MFN No. 38-89
Docket No. STN 50-605

Subject: **Resolution of Outstanding ABWR SSAR Issues**

RESOLUTION OF OUTSTANDING ABWR SSAR ISSUES

Figure 440.103-1
ATWS LOGIC

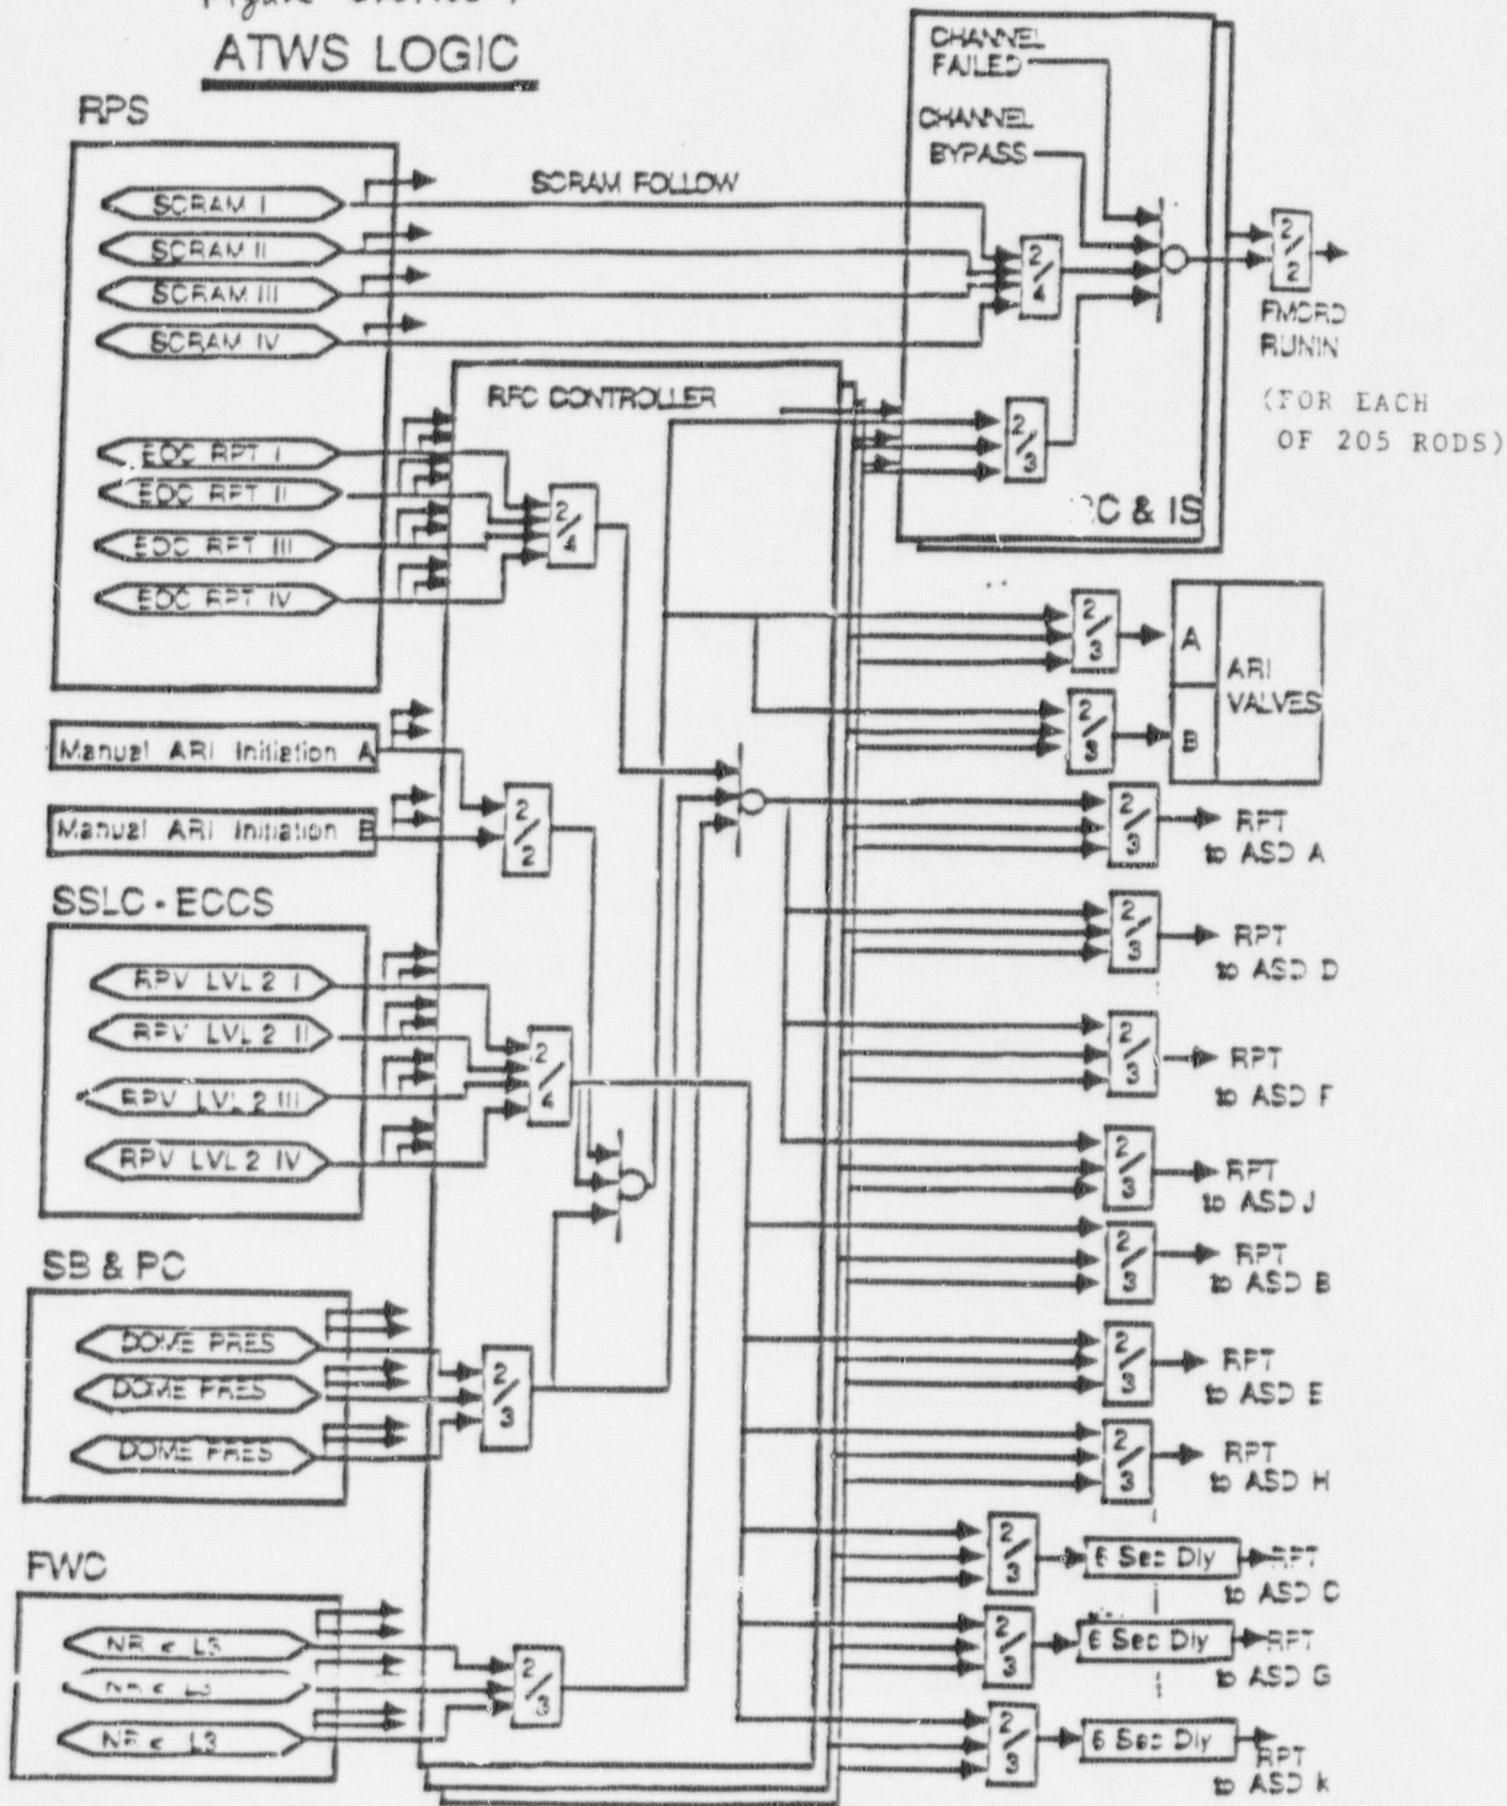
In the ABWR design, SLCS pump is started manually. But the ATWS rule 10 CFR 50.62 states that "The SLCS initiation must be automatic and must be designed to perform its function in a reliable manner for plants granted construction permits after July 26, 1984." How does the ABWR design satisfies the ATWS rule? (9.3.5)

The ARI design follows the guidelines for the design objectives and design basis requirements for the ARI system as documented in NURE-31096-P-A (ATWS, Response to NRC ATWS Rule 10CFR50.62, approved by the NRC in October, 1986). The ABWR ATWS trip logic, as shown in the attached Figure 440.103-1, is highly reliable and single-failure-proof.

It is concluded from above analysis results that manual boron injection with either one or two SLC pumps could mitigate the most limiting ATWS event with margin (at least 15 psi margin in peak containment pressure). From this margin, it is estimated that the operator has about 10 minutes to inject the boron into the vessel in order to maintain the containment integrity following an ATWS event. Therefore, a manual SLCS injection (even with one pump) as a backup for ATWS mitigation is acceptable.

Figure 5.4-7 MAIN STEAM ISOLATION VALVE

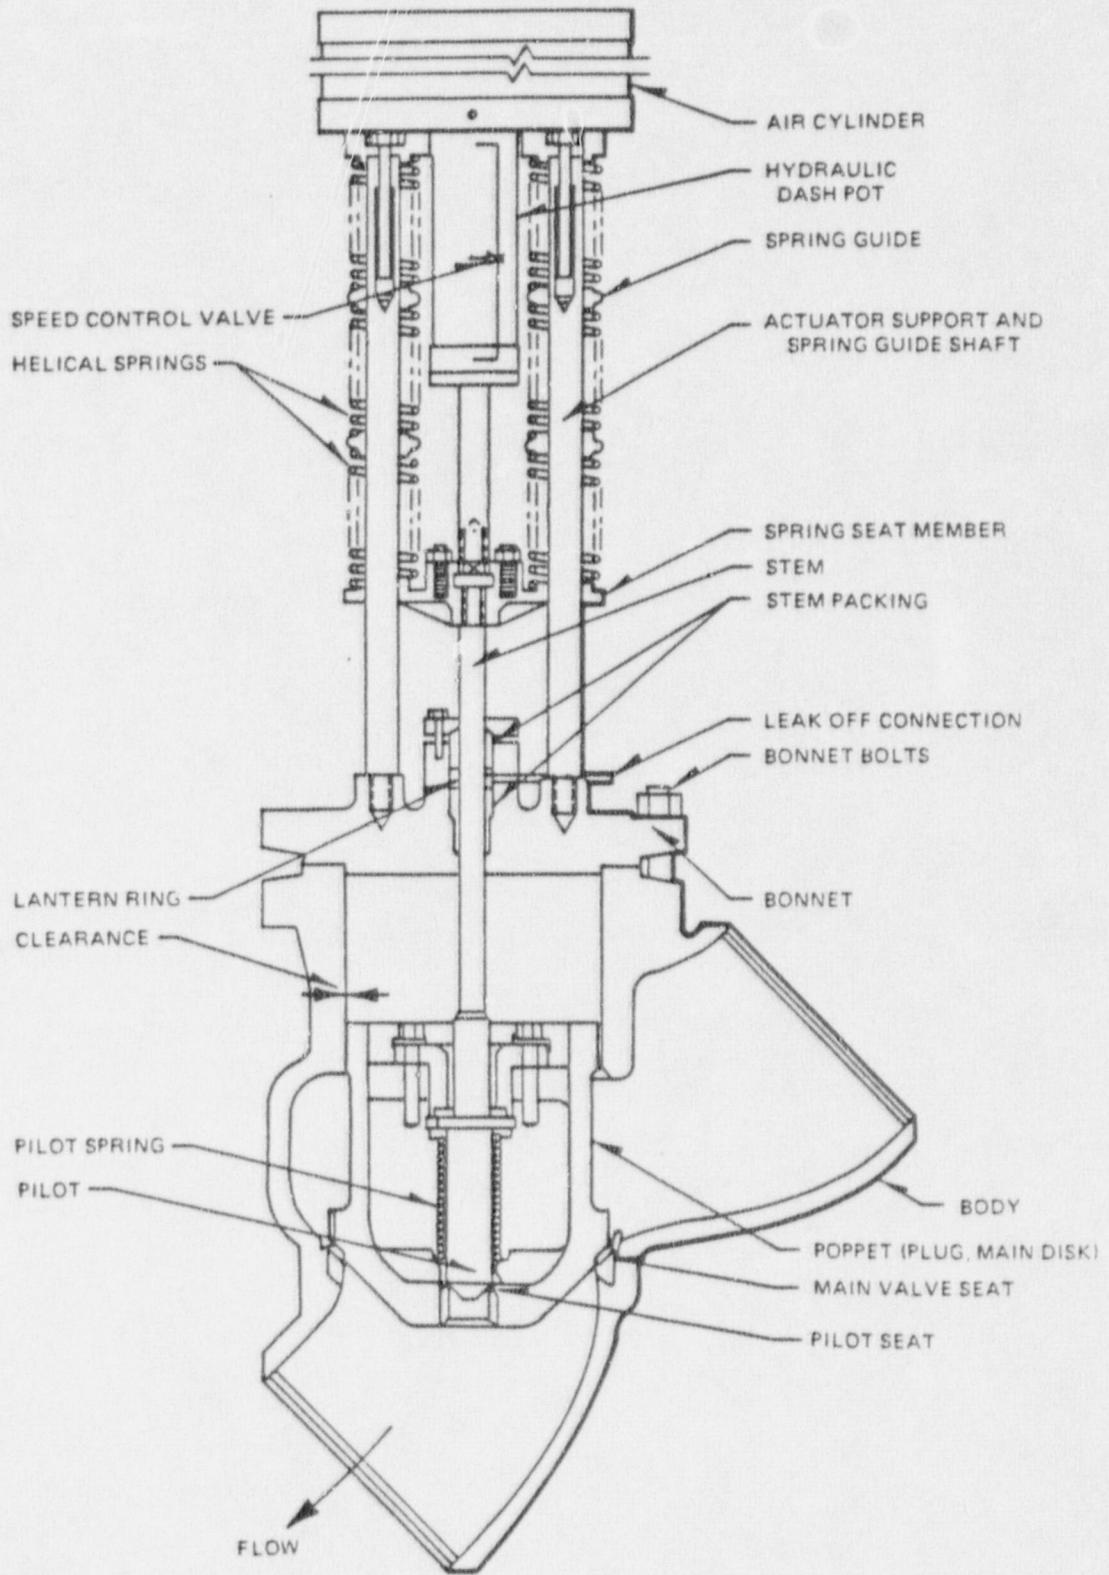
Finally, Attachment 3 provides a draft amendment to the SSAR which updates Subsection 5.4.5, "Main Steamline Isolation System". The major change is in the main steam isolation valve (MSIV). Following an extended and thorough review of MSIV operating experience by the Japanese ABWR Project, the decision was made to use the MSIV design installed in current operating BWRs and apply the improvements to this basic design which have been demonstrated in Japan.

Figure 5.4-7 shows a main steamline isolation valve. Each is a Y-pattern, globe valve. Rated steam flow through each valve is 4.23×10^6 lb/hr. The main disc or poppet is attached to the lower end of the stem. Normal steam flow tends to close the valve, and higher inlet pressure tends to hold the valve closed. The bottom end of the valve stem closes a small
